ADDENDUM ONE

BLACKFEET COMMUNITY HOSPITAL
EXPANSION & RENOVATION
PHASES 1 & 2
BROWNING, MONTANA

CONTRACT: 102-96-0005
ORDER: 006
PROJECT: BI7BF079H7

17 August 1999

SX1

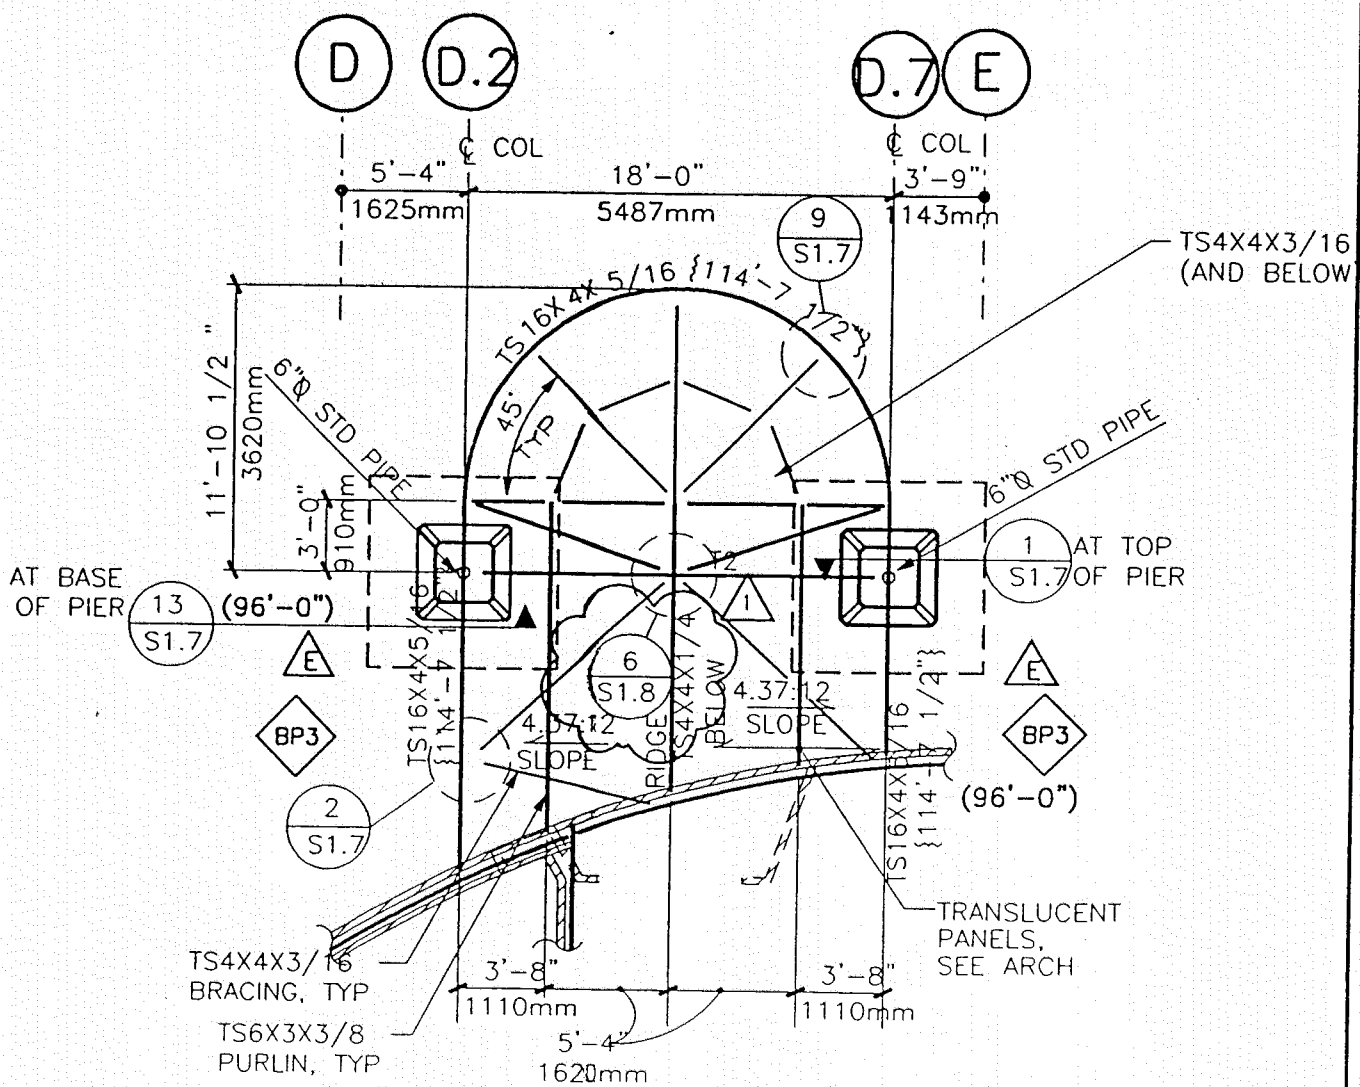
G. S1.7, CANOPY PLAN – AREA A.

Refer to the revised detail 6/S1.8 instead of 6/S1.7 as shown on the attached sketch, SX-1.

Sheet #
 SX3
 Of 6

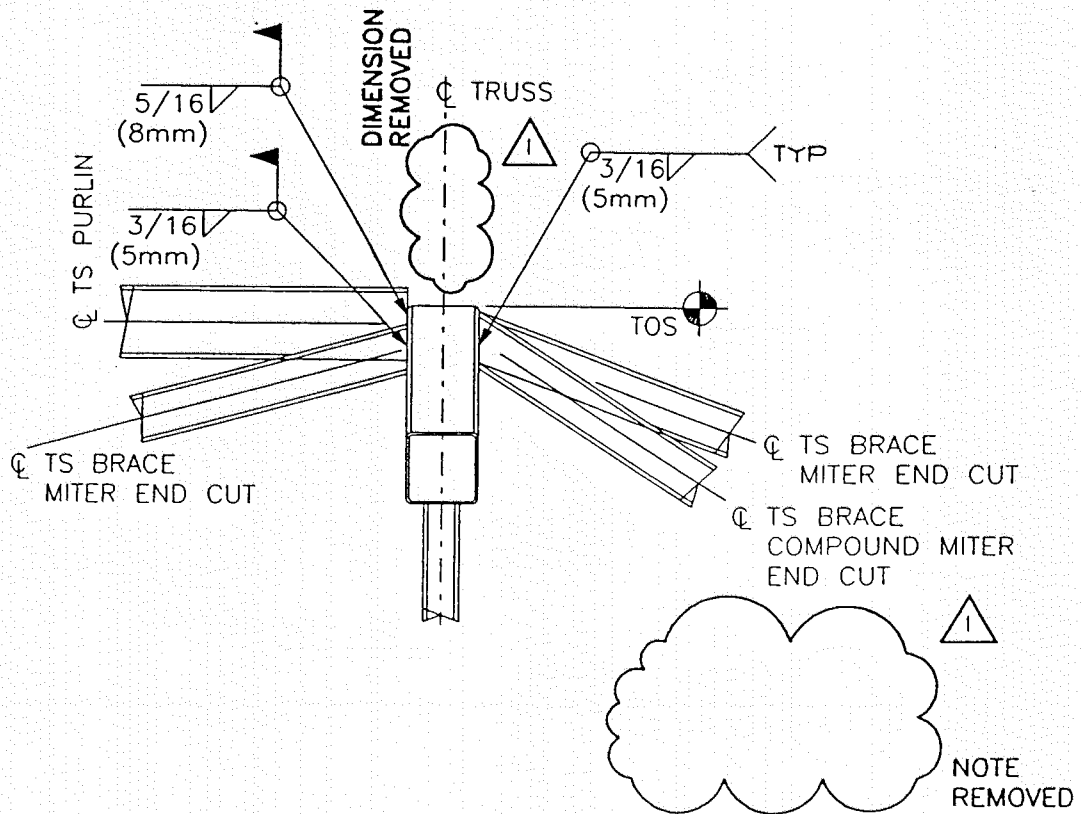
- I. 8/S1.7, DETAIL.
Dimension and note have been removed for clarification. Refer to SX-3.
 - J. 6/S1.8, CONNECTION DETAIL.
Connection detail is added as referenced in revised detail on S1.7, Canopy Plan, as shown above. Refer to SX-4.

SX5

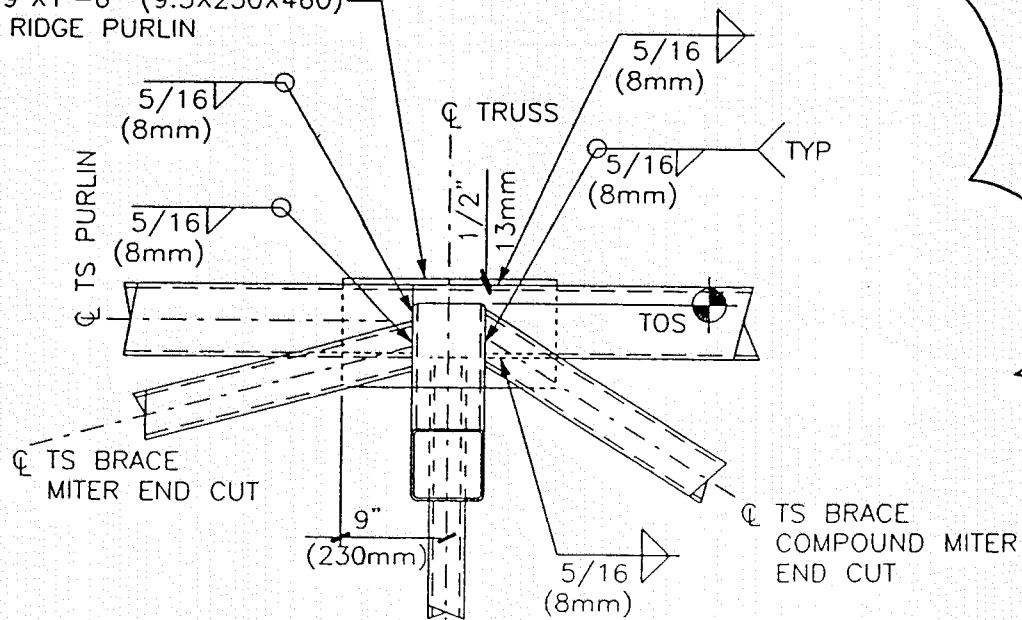
- K. 7/S1.8, DETAIL.
Detail at truss connection is added as referenced in new detail 6/S1.8, above. Refer to SX-5.
 - L. 8/S1.8, DETAIL.
Added detail for brace below interior planter. Refer to attached sketch SX-6.

SHEET NUMBER
EX-1

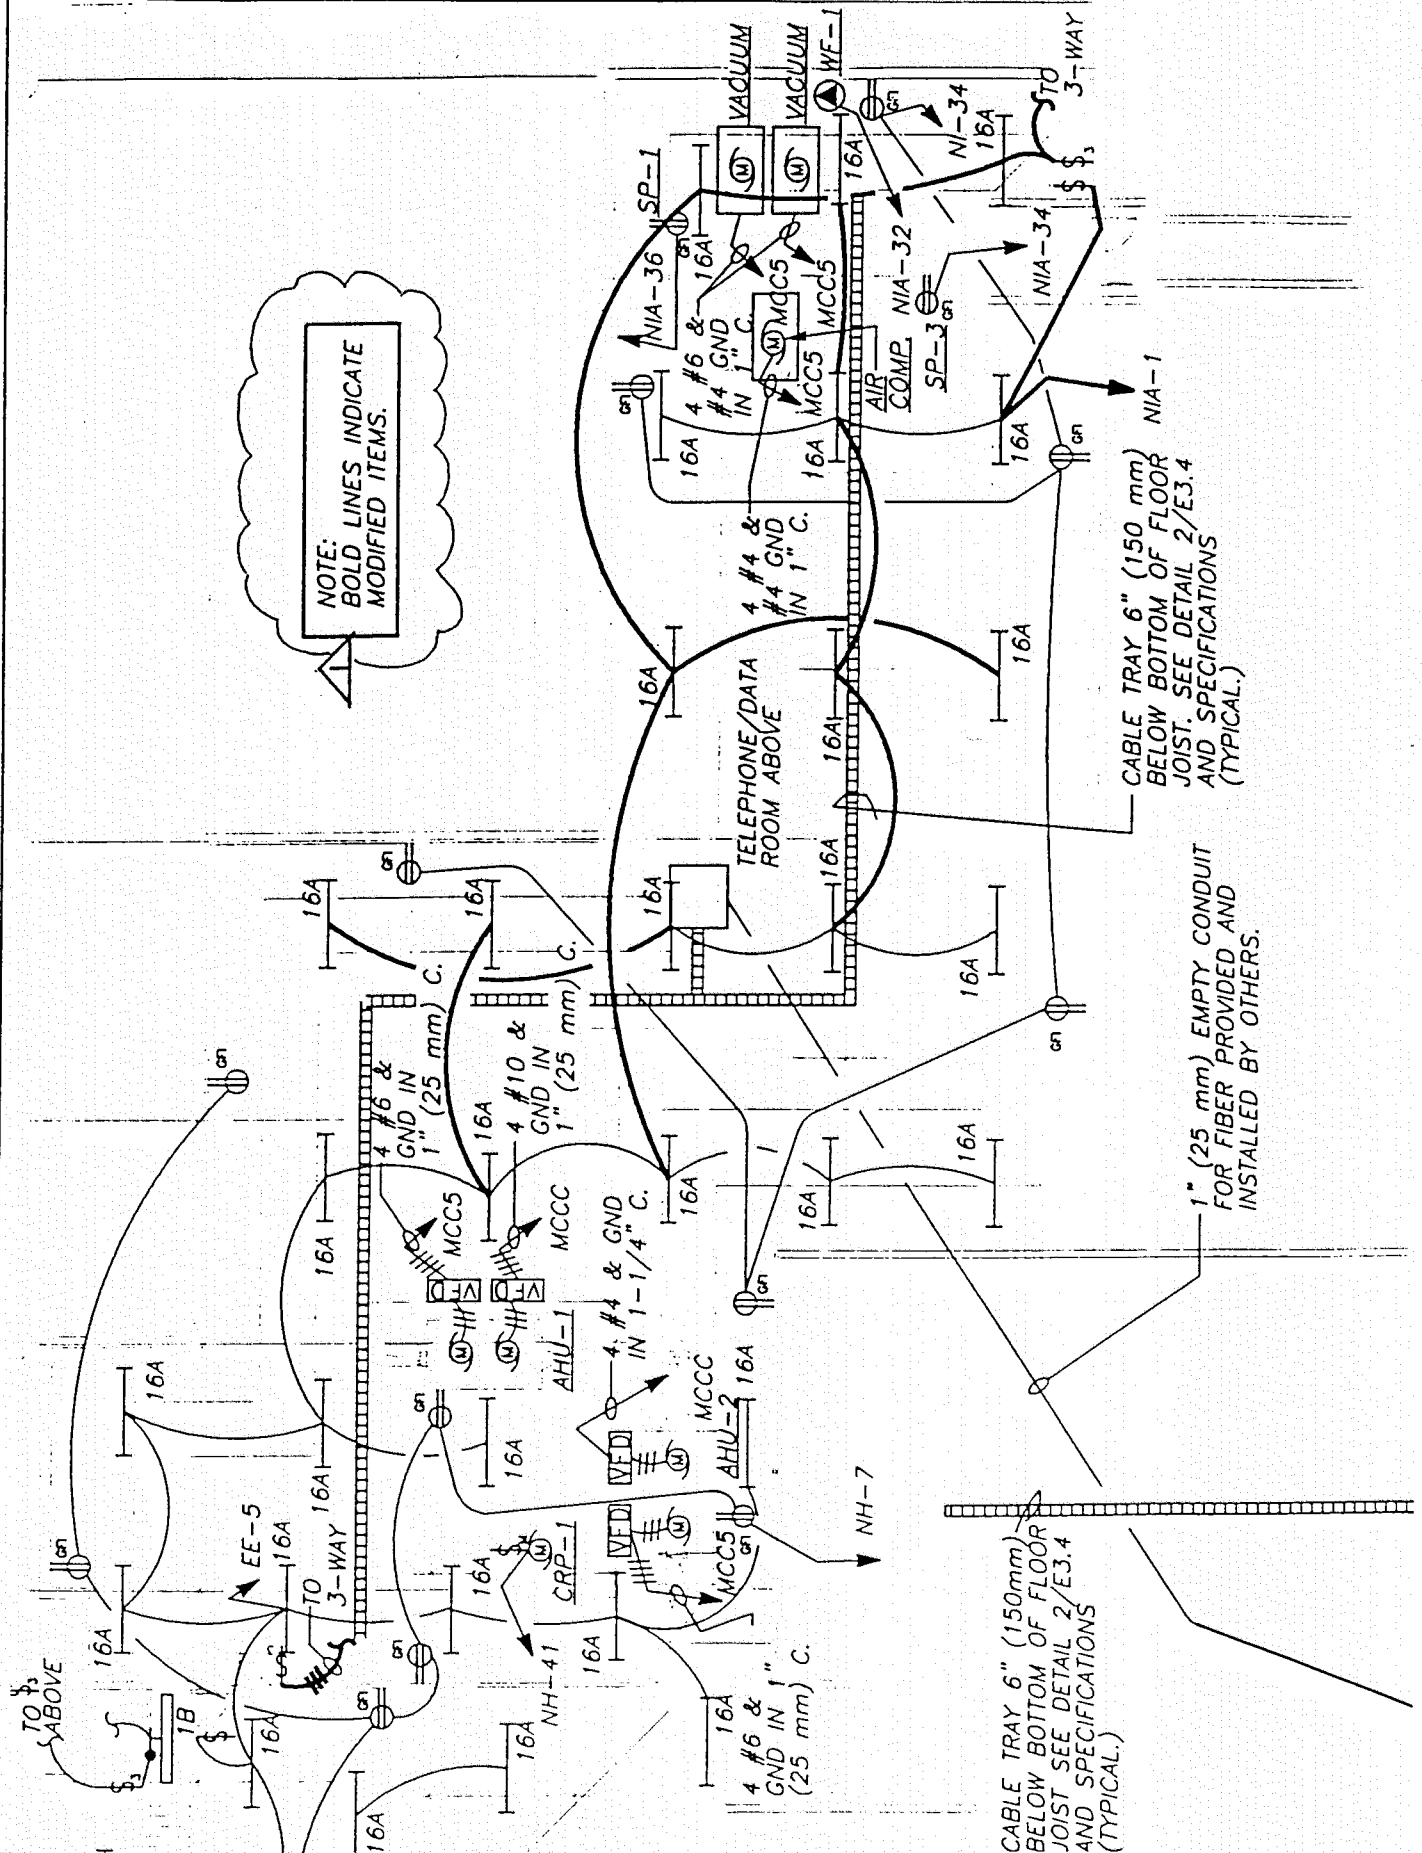
- P. 1/E3.4, CRAWLSPACE – POWER AND LIGHTING PLAN.
-

Add five (5) type '1A' fixtures to circuit #EE-5, switch from two (2) new 3-way switches as shown in the attached drawing, EX-1.
